DOCKET ITEM #7

Development Special Use Permit with Site Plan #2007-0035
Mixed Use Office/Retail– 2903 Mount Vernon Avenue

Purpose of Application

Redevelopment of an automobile repair facility at the intersection of Mount Vernon Avenue and Commonwealth Avenue as a two-story office building with ground floor retail with at-grade parking, under the Mount Vernon Avenue Plan Design Guidelines.

Figure 7: Zone Transition Line

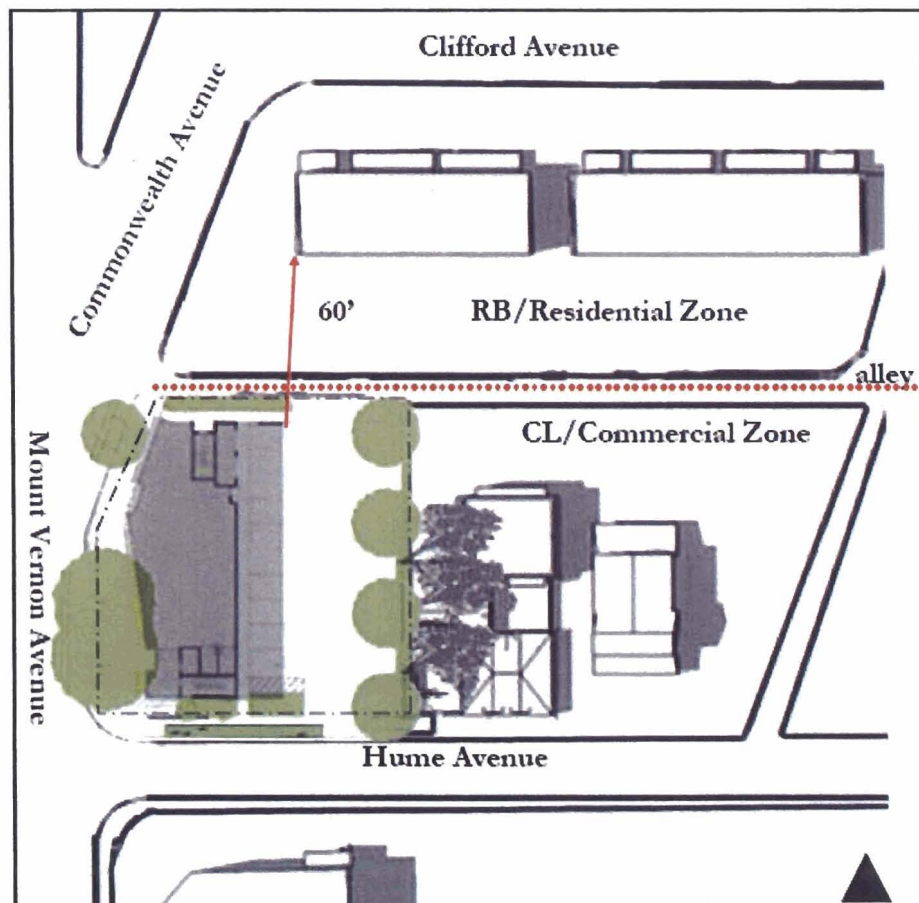
A zone change line runs down the center of the alley at the north side on the property, shifting from Commercial (CL Zone) to the adjacent Residential (RB Zone). Section 7-902 of the Zoning Ordinance requires a setback from the adjacent residential zone line equal to the height of the commercial building or 25', whichever is greater, in order to ensure that residences adjacent to commercial uses are not adversely affected. The applicant is requesting that the Planning Commission grant a modification to this requirement as part of the site plan process, per Section 7-903 of the Zoning Ordinance.

Under the existing zoning, the 28' high building would need to be set back 28' from the zone transition line, and under the current proposal, it is set back 15 feet, requiring a modification of 13 ft. To achieve the required 28' setback, the building would not be in compliance with the street frontage requirements of the Mount Vernon design guidelines, requiring buildings to define 100% of the street frontage along Mount Vernon Avenue. Additionally, if the building were to meet the setback requirement, a large gap in the street frontage would make the alley and parking lot more visible from Mount Vernon Avenue.

There are several homes along Clifford Avenue that abut the alley in this location. With approximately 60 feet of distance between the homes and the proposed building, including a public alley in between, staff is of the opinion that there is adequate separation between the uses. Staff has also added conditions to provide a high-quality landscape buffer between the building and the alley to help screen the building as well as the parking lot.

Staff believes that in this case, the modification will not be detrimental to the neighboring properties, nor to the public health, safety and welfare and therefore supports the modification.

Turning radius analysis for
curb cut on Hume Ave.

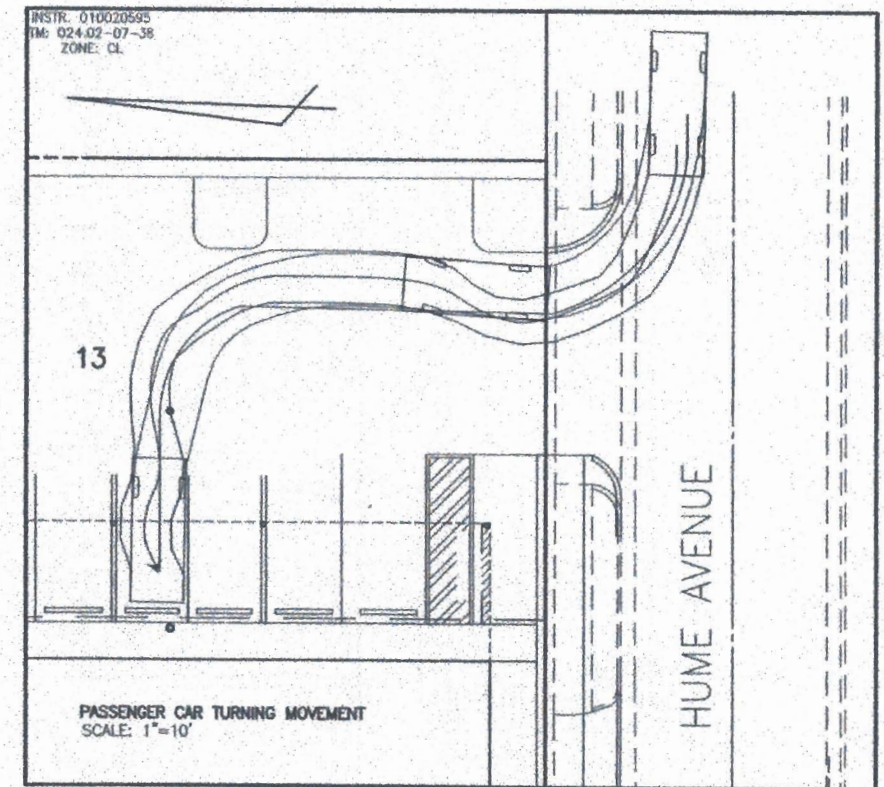
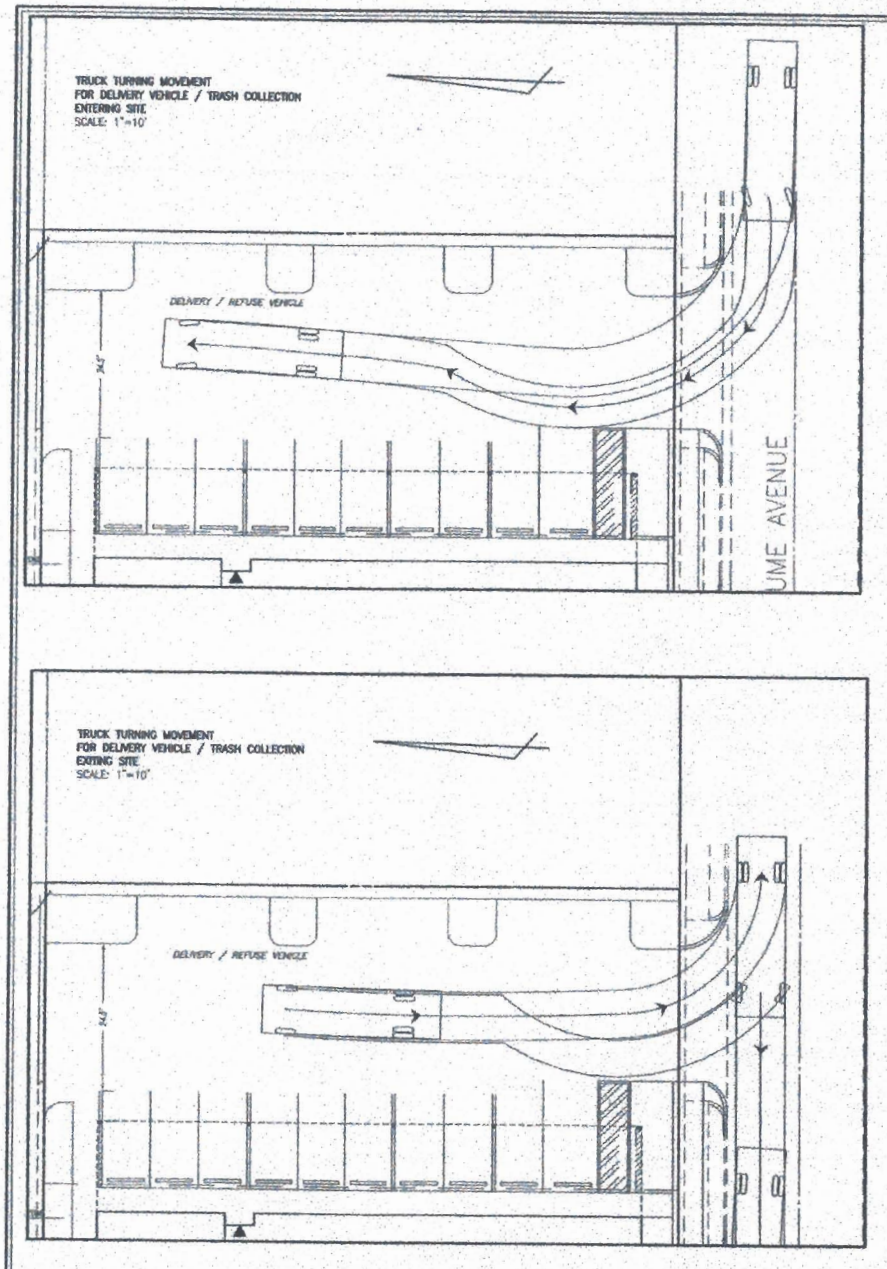
Alley
Primarily
Serving
Residences

Staff did not require
analysis for alley
